TECHNICAL MEMORANDUM

Subject: 923-925 5th Street Hotel – Response to MCV Memorandum dated April 4, 2018

Inbound from I Street, NW

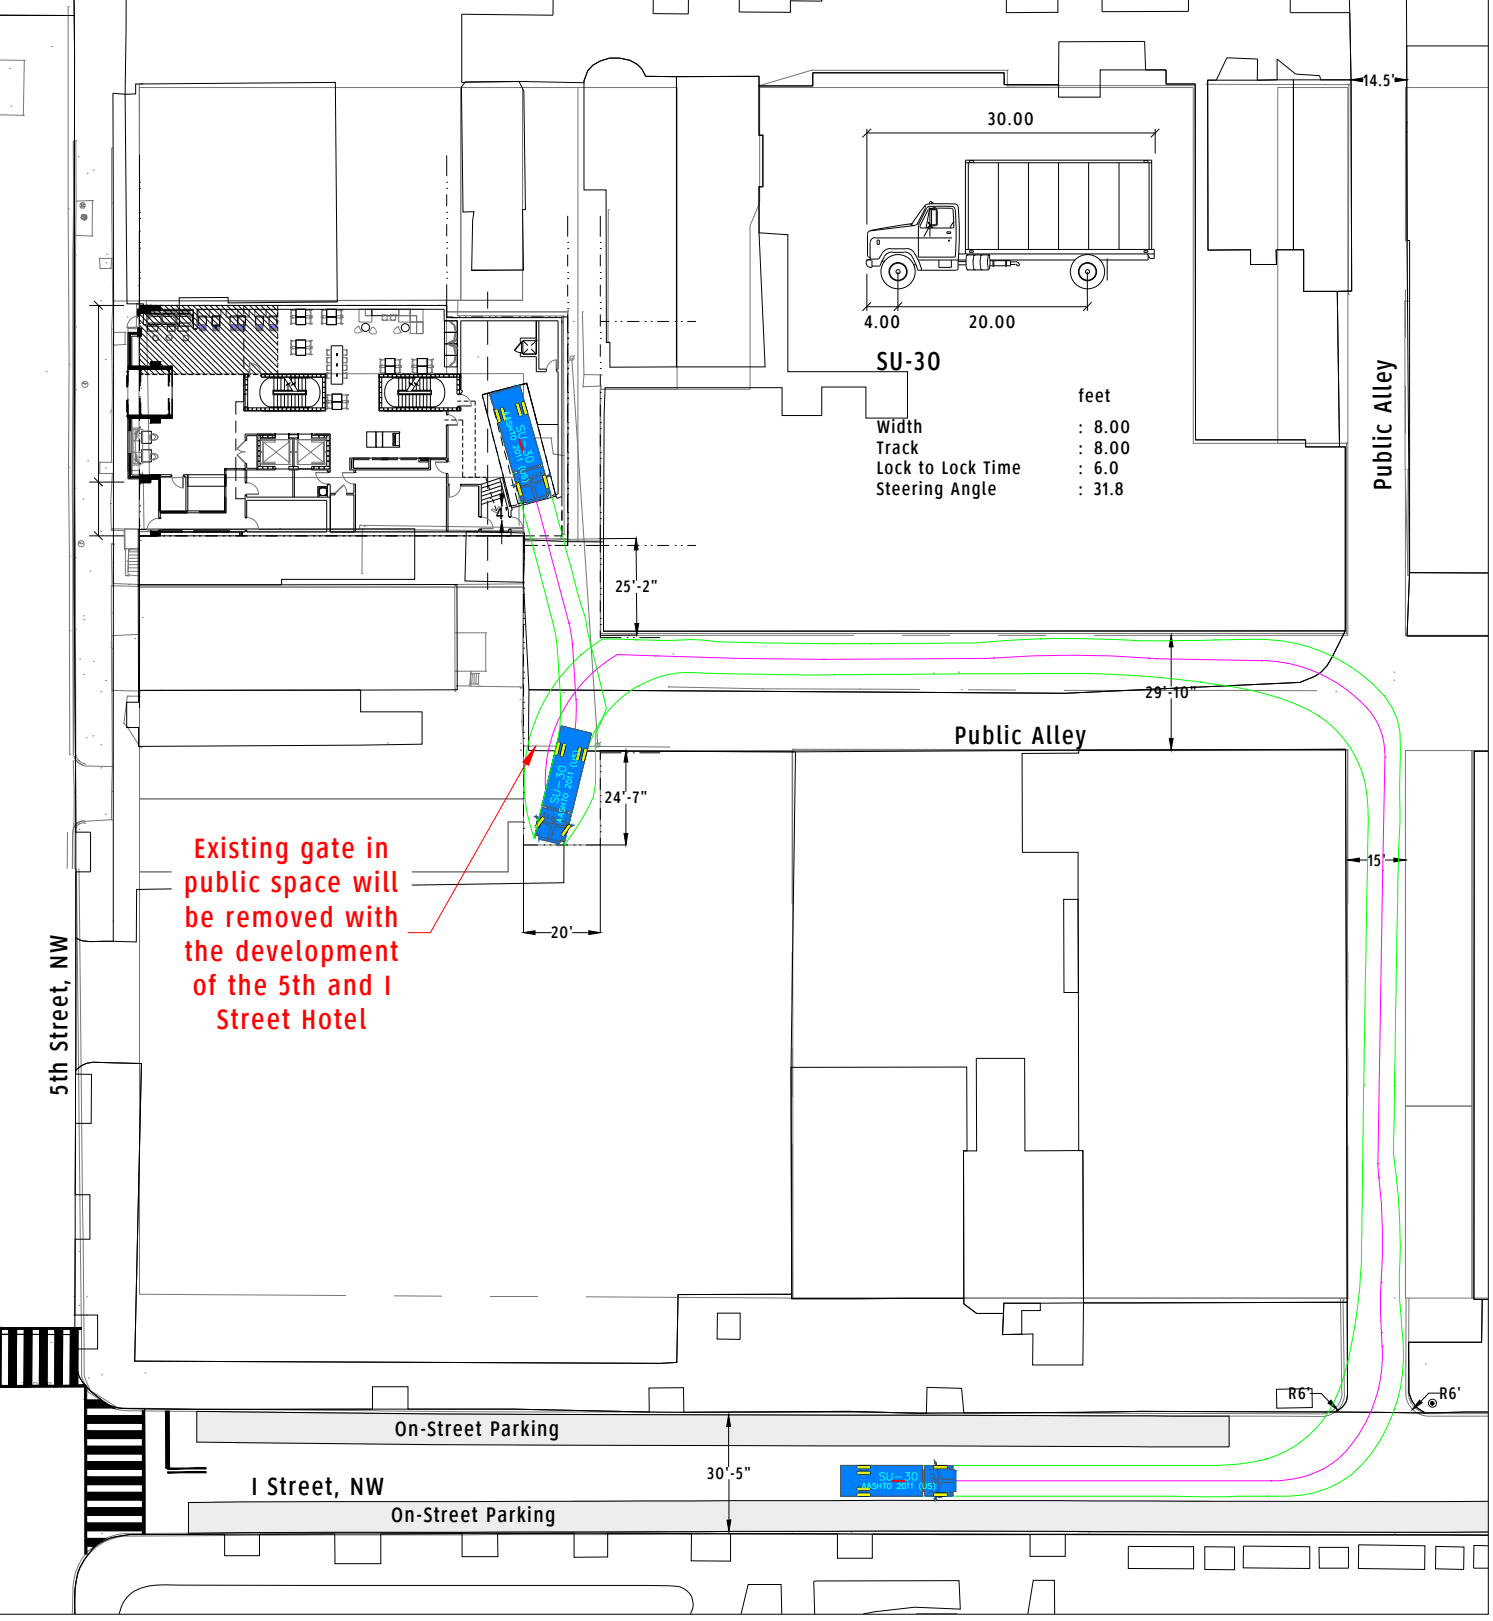
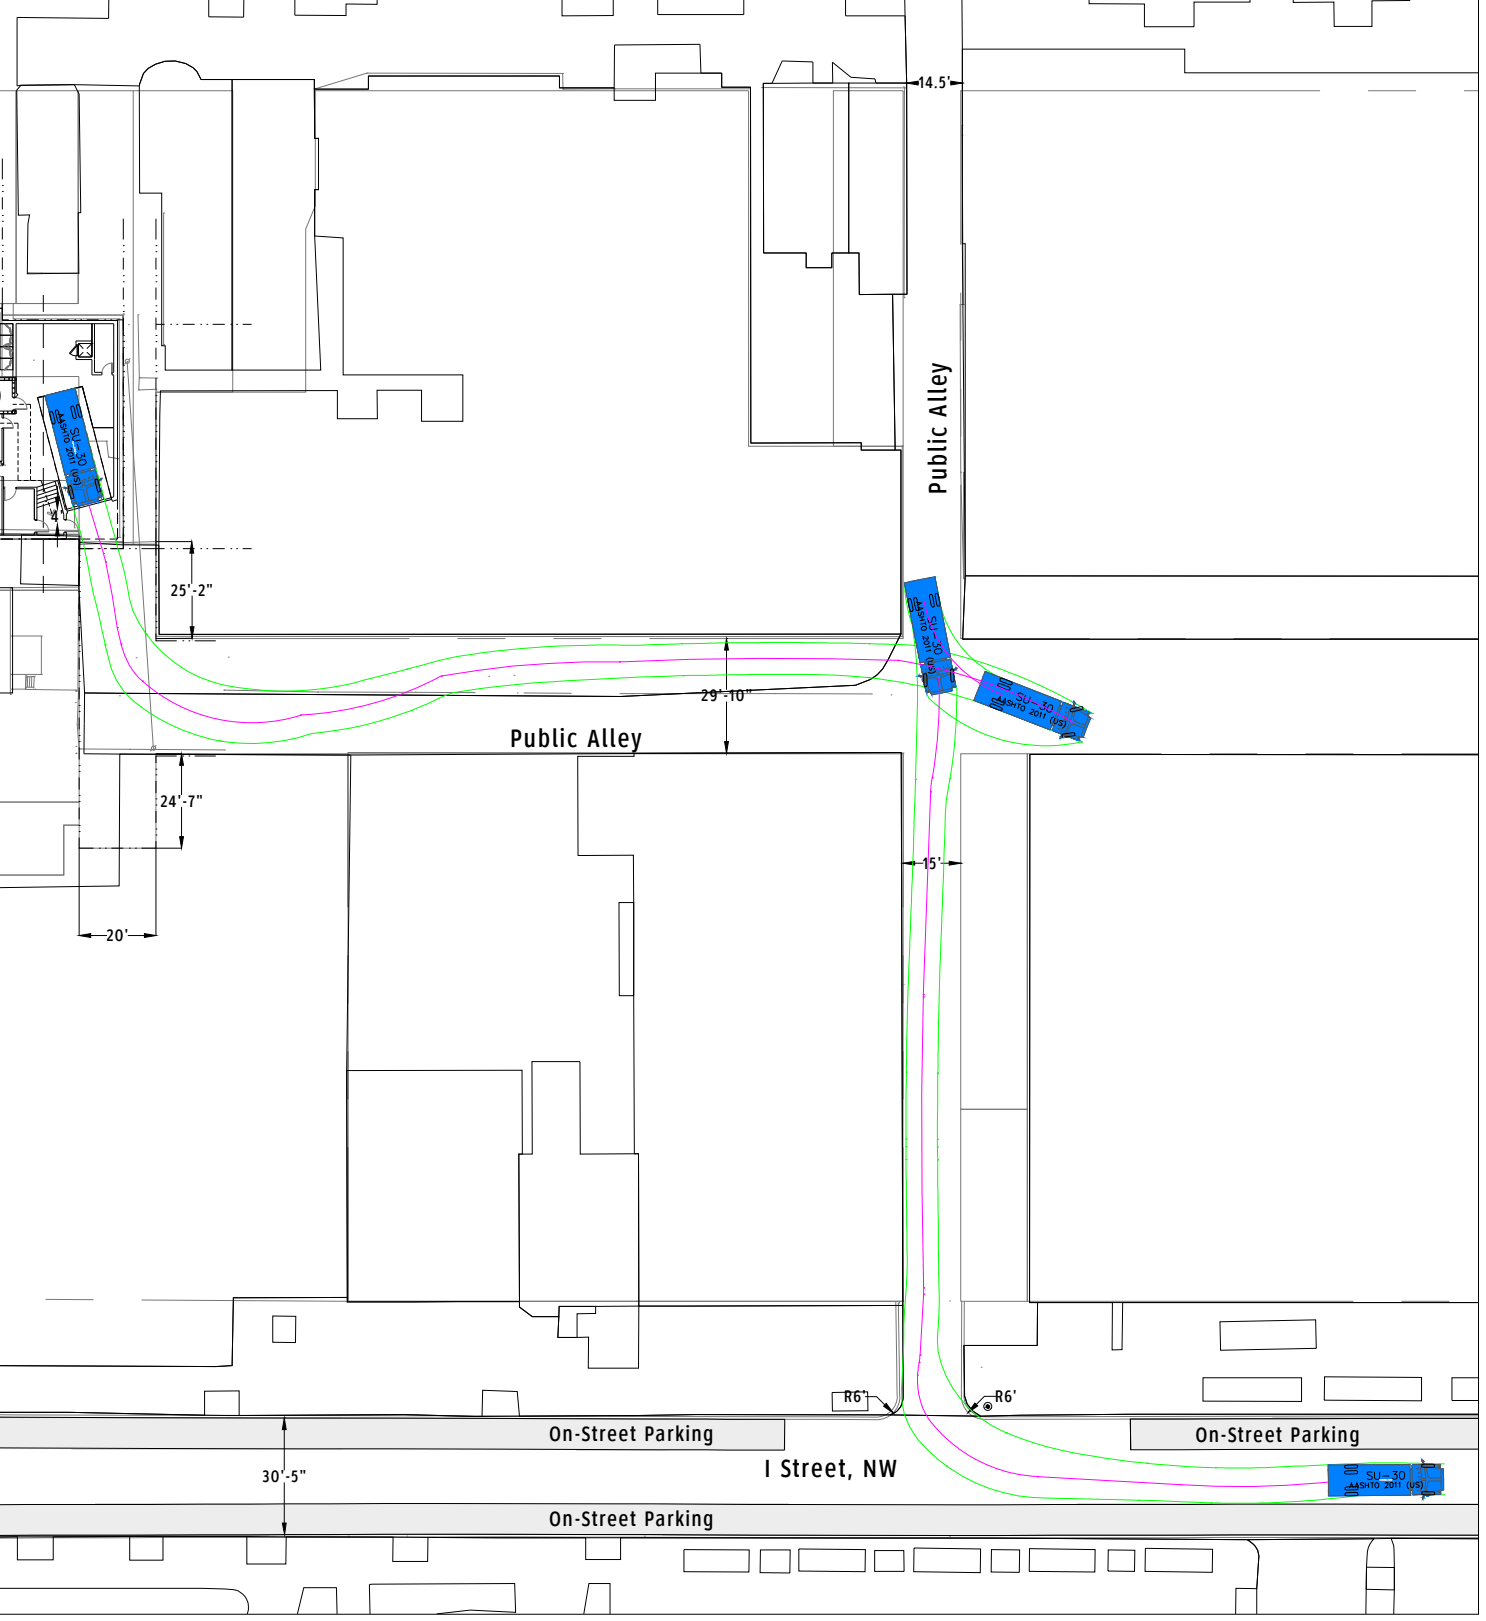
10. *Excerpt from MCV memo: The Gorove/Slade AutoTURN shows that the trucks will clip the I Street building on the east side as it leaves the loading dock. Further, the outbound movement from the loading dock looks to be touching the edge of the loading dock wall.*

11. *Excerpt from MCV memo: The AutoTURNs do not take into account the on-street parking along both sides of I Street NW (inbound and outbound)"*

12. *Excerpt from MCV memo: The location of the loading dock for the proposed hotel is in a narrow alley requiring back in maneuvers. The site's alley access is constrained by existing walls on adjacent properties, limiting entry aisle of the alley to be 11.5 feet wide. The trucks will need to back into the proposed angled space of 11.5 feet, which will require the removal of an existing fence at the alley's hammerhead.*

Gorove/Slade Response: The revised AutoTurn exhibits attached to this memo demonstrate that 30-foot truck maneuvers do not clip the I Street building. Also shown on the revised AutoTurn exhibits, the outbound truck movement from the proposed hotel loading dock does not encroach the edge of the loading dock wall.

Gorove/Slade Response: The AutoTurn exhibits presented in the March 1, 2018 CTR did not account for on-street parking. The revised AutoTurn exhibits attached to this memo show 30-foot trucks maneuvering in and out of the alley from I Street without encroaching the on-street parking spaces.

Gorove/Slade Response: The revised AutoTurn exhibits attached to this memo demonstrate the 30-foot-long truck (8 feet wide) will be able to maneuver through the 11.5 feet wide entry aisle. It should be noted, the existing fence called out in the MCV memo will be removed as part of the proposed development at the corner of 5th Street and I street as it is in public right-of-way. The removal of the fence allows the inbound maneuver to reach the proposed loading dock. Furthermore, the vast majority of loading docks are designed to accommodate back-in/head-out maneuvers; therefore, truck drivers are used to doing back-in movements in almost all circumstances without the need for additional assistance from another person guiding the driver.

Inbound from K Street, NW

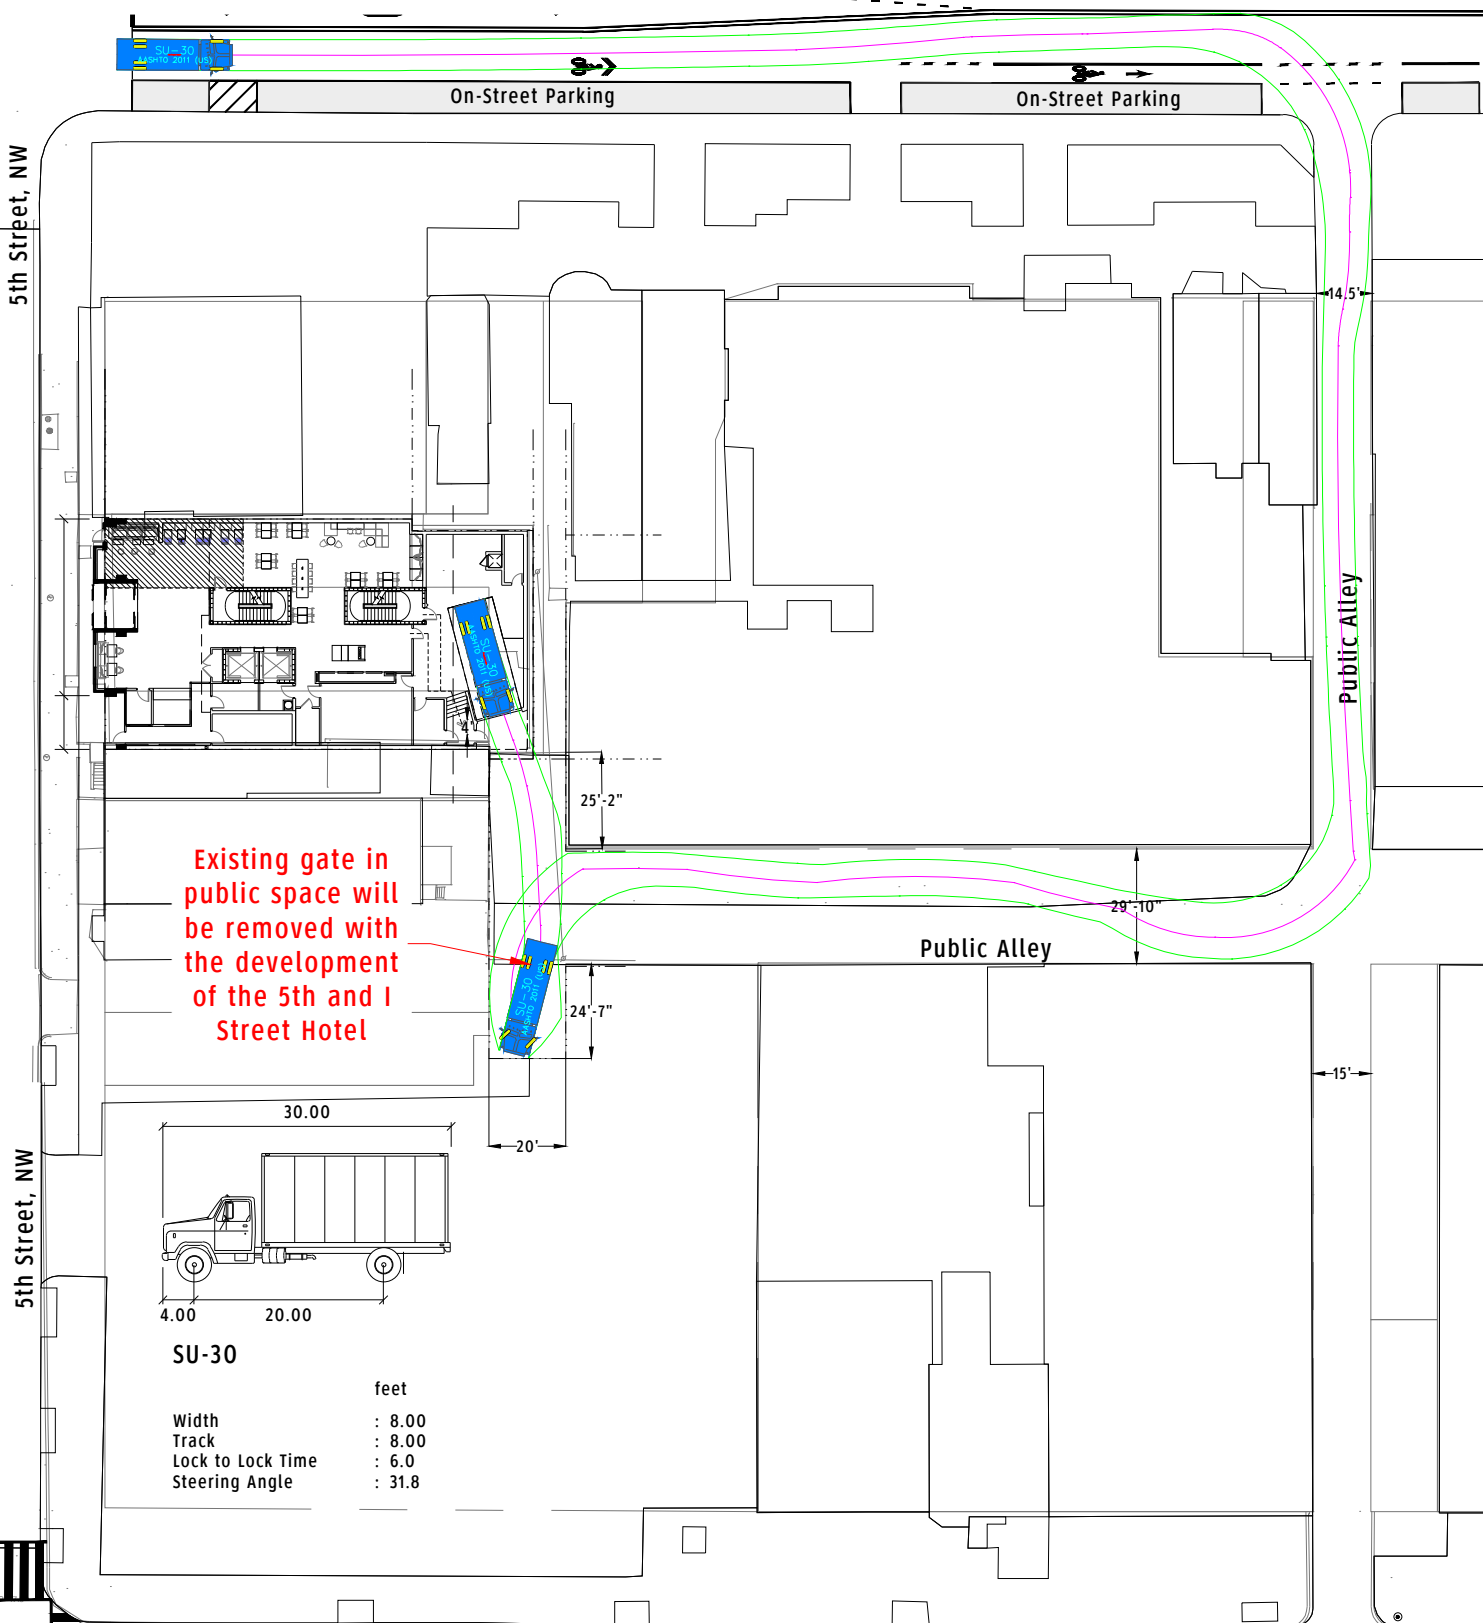
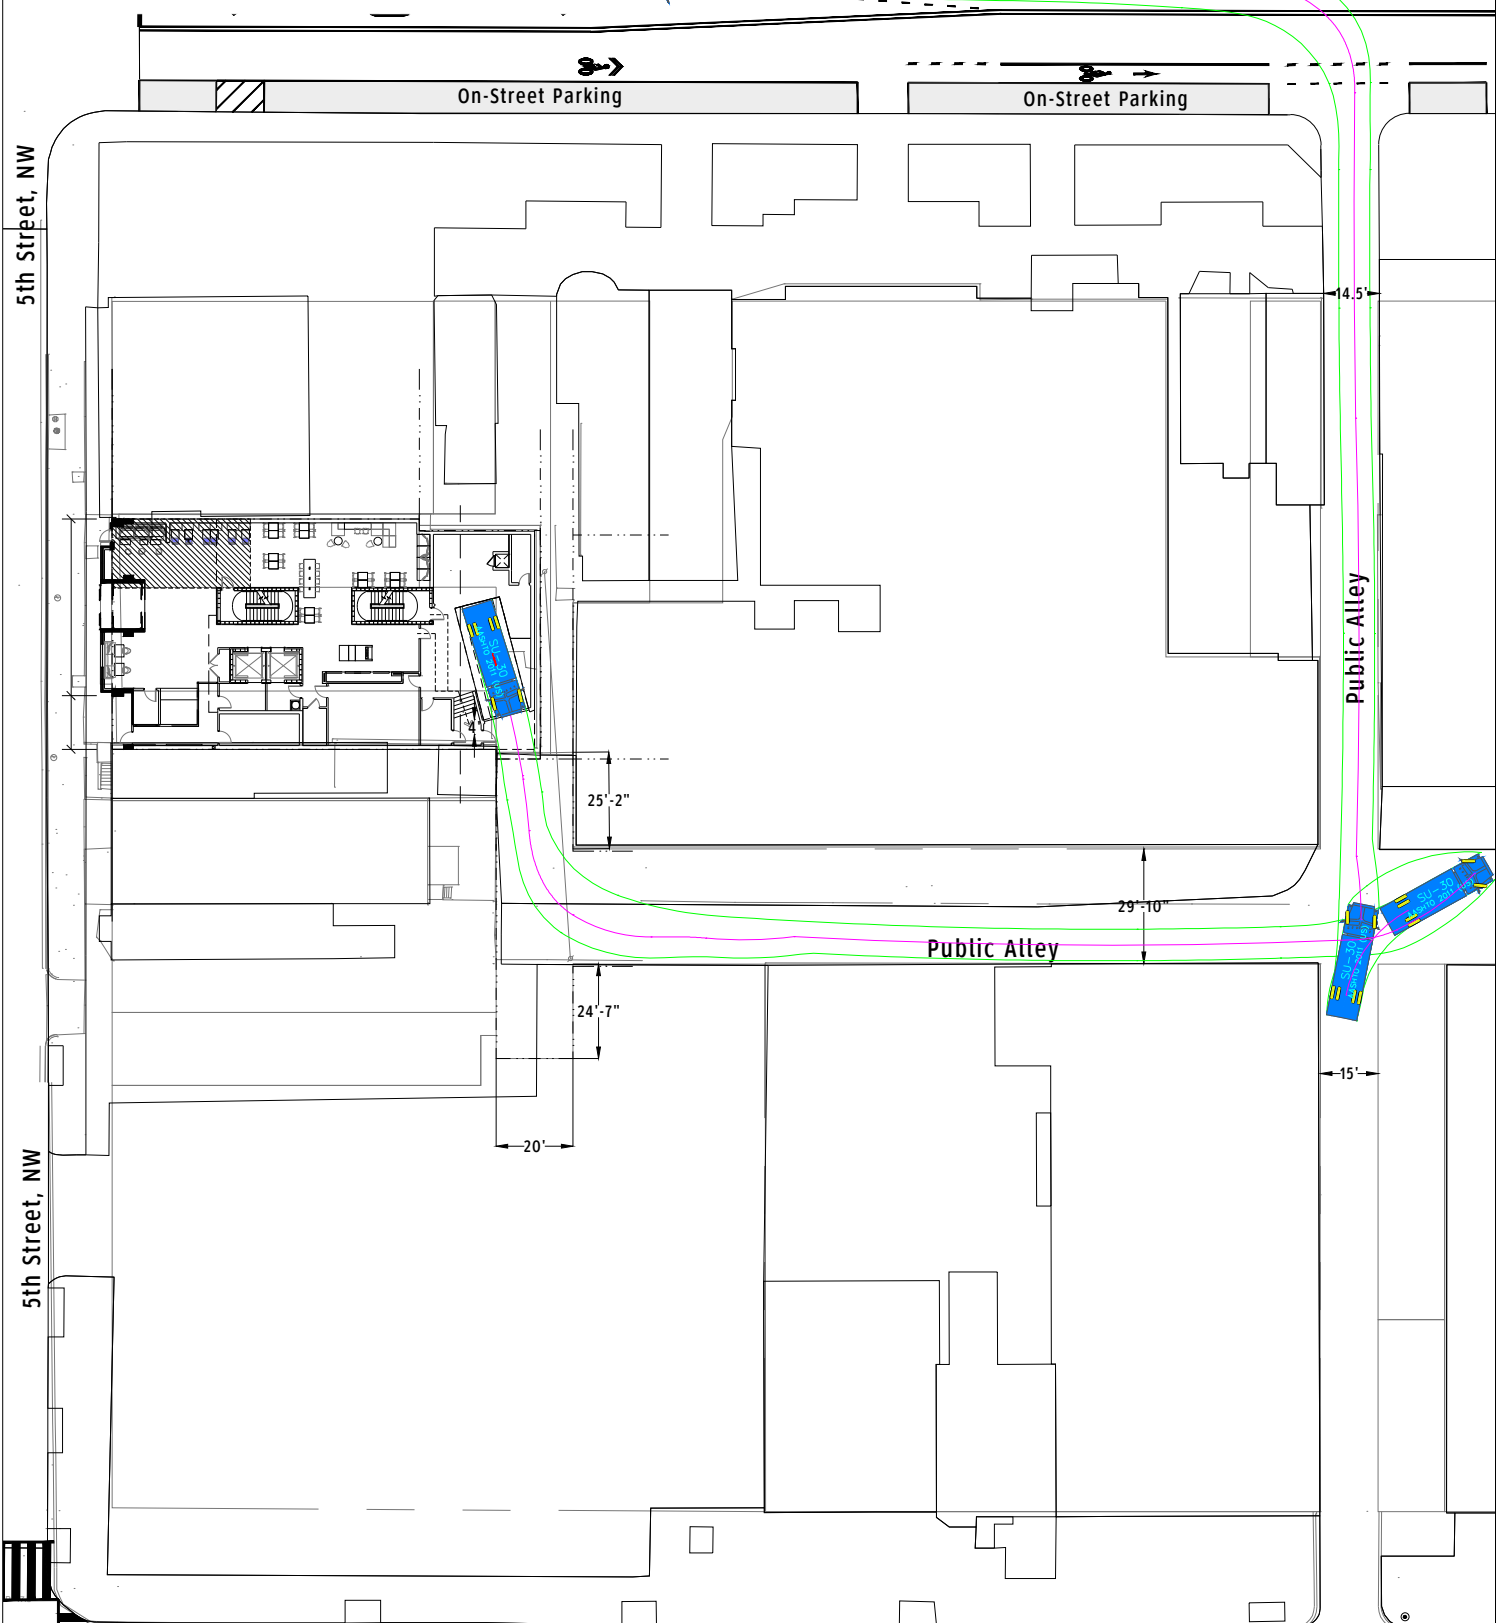
- 7. Excerpt from MCV memo: Gorove/Slade did not provide AutoTurn maneuvers that proved the loading dock could be accessed by an SU-30. The single loading dock is situated such that it would not be accessible based on the truck maneuvers developed using AutoTURN.*

Gorove/Slade Response: Inbound and outbound AutoTurn exhibits have been prepared and are attached to this memo. The exhibits show a 30-foot truck maneuvering in and out of the loading dock provided for the proposed hotel, with the truck entering from both K and Eye Streets NW.
